O. L. Olson, Project Manager
BWIP Project Office
U.S. Department of Energy
Box 550
Richland, Washington 99352

Enclosure:
Follow-up Comments on DOE/NRC
Hydrogeology Workshop

FOLLOW-UP COMMENTS ON JUNE 1984 DOE/NRC HYDROGEOLOGY WORKSHOP

FIGURE 1

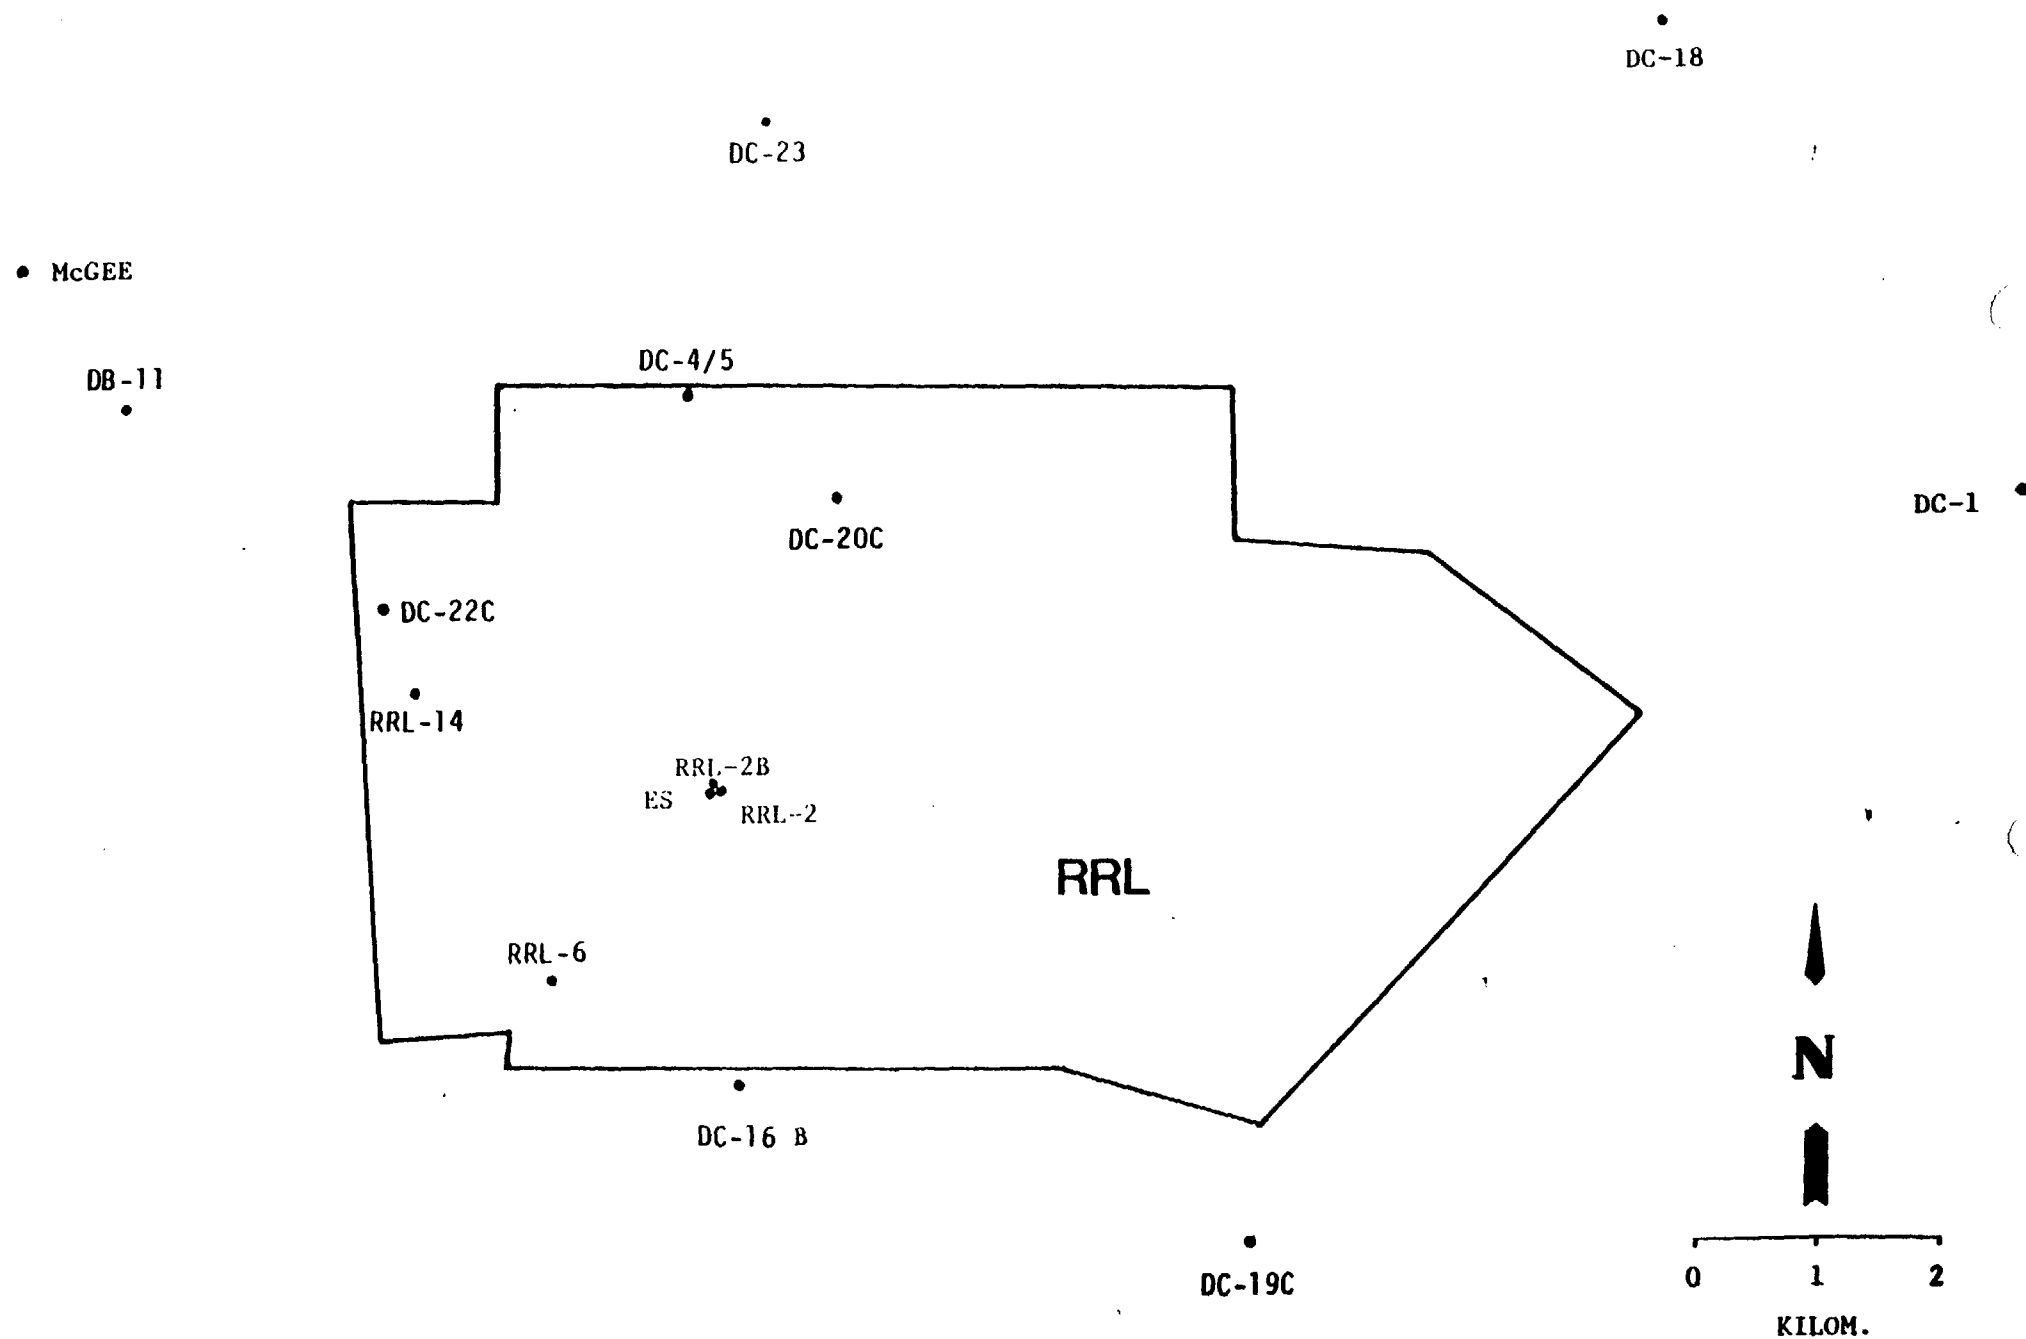
During the June 1984 NRC/BWIP Hydrogeology Workshop, BWIP presented an updated description of the status of and plans for hydrogeologic monitoring and testing at the BWIP site. The presentations indicated that substantial progress had been made toward implementation of the testing strategy discussed during the July 1983 meeting. In particular, the nested piezometers in boreholes DC-19C, DC-20C and DC-22C had been installed with reasonable success, and the hydrologic baseline monitoring had begun. In addition, the feasibility of the planned large-scale hydraulic stress (LHS) tests was clearly demonstrated by observations of drawdowns in DC-16B, DB-14, and DC-1 during air-mist drilling of the cluster "C" holes. Throughout this document please refer to Figure 1 which illustrates, relative to the boundaries of the Reference Repository Location (RRL), the locations of most of the boreholes discussed in this letter.
